**YEAR 7 (2022) MONITORING REPORT**  
**AYCOCK SPRINGS**  
**STREAM AND WETLAND MITIGATION SITE**

ALAMANCE COUNTY, NORTH CAROLINA  
DMS PROJECT No. 96312  
FULL DELIVERY CONTRACT No. 5791  
NCDWR PROJECT No. 20140335  
USACE ACTION ID No. SAW-2014-01711

## Response to Monitoring Year 7 (2022) DMS Comments

Aycock Springs Stream and Wetland Mitigation Site (DMS #96312)  
Cape Fear River Basin 03030002, Alamance County  
Contract No. 005791

<b>Site</b>	Aycock Springs
<b>Watershed:</b>	Cape Fear, 0303002
<b>XS ID</b>	Travis Creek, XS - 4, Riffle
<b>Feature</b>	Riffle
<b>Date:</b>	2/10/2022
<b>Field Crew:</b>	Adams, Harris, Perkinson

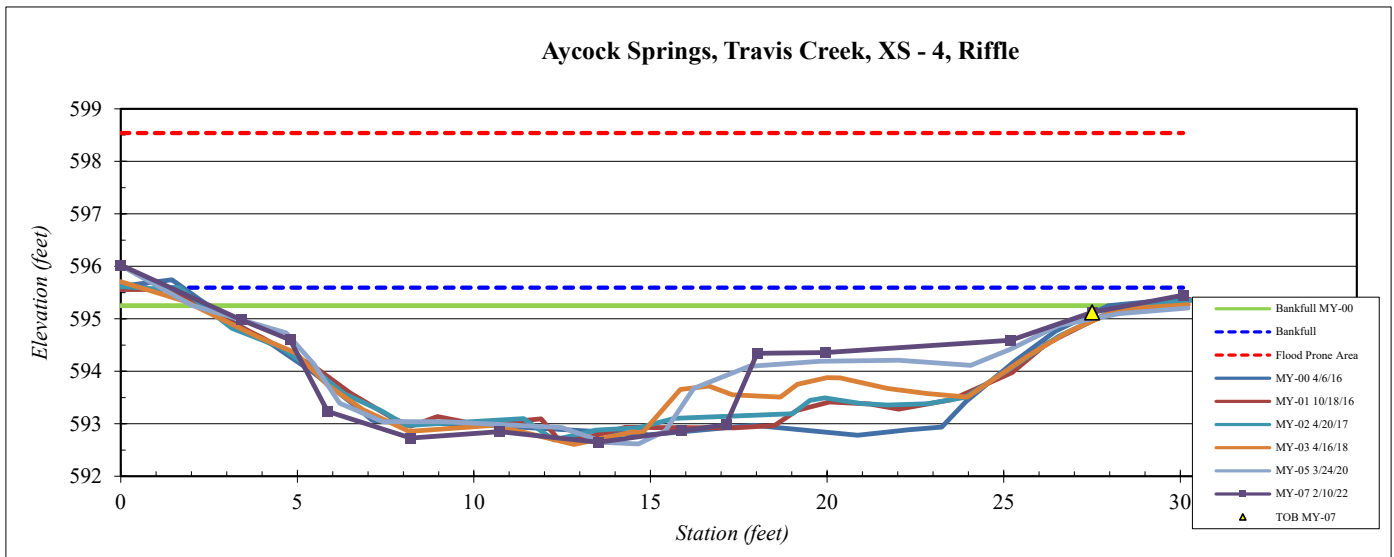
- b. On XS-4, since the Bankfull line based on MY0 cross-sectional area (blue-dotted line) is above the elevation of the LTOB, should the BHR be a number <1? Please clarify.

- d. Check footnotes that are under the cross section graphs (XS-4 for example). Some letters are missing (not sure if a typo or error when converting or compressing the file).

**Response:** Based on the MY0 cross-sectional area, the unrounded Dmax value is 2.945892999999996 and LBH is 2.802893000000004, making the BHR ~0.95, which was rounded to 1 in the cross-section report and Table 11A. These values have been corrected to "<1".

**Response:** Thank you for catching this – it appears to have occurred during the file compression process. To ensure this doesn't occur again, the final electronic copy of the report was not downsized.
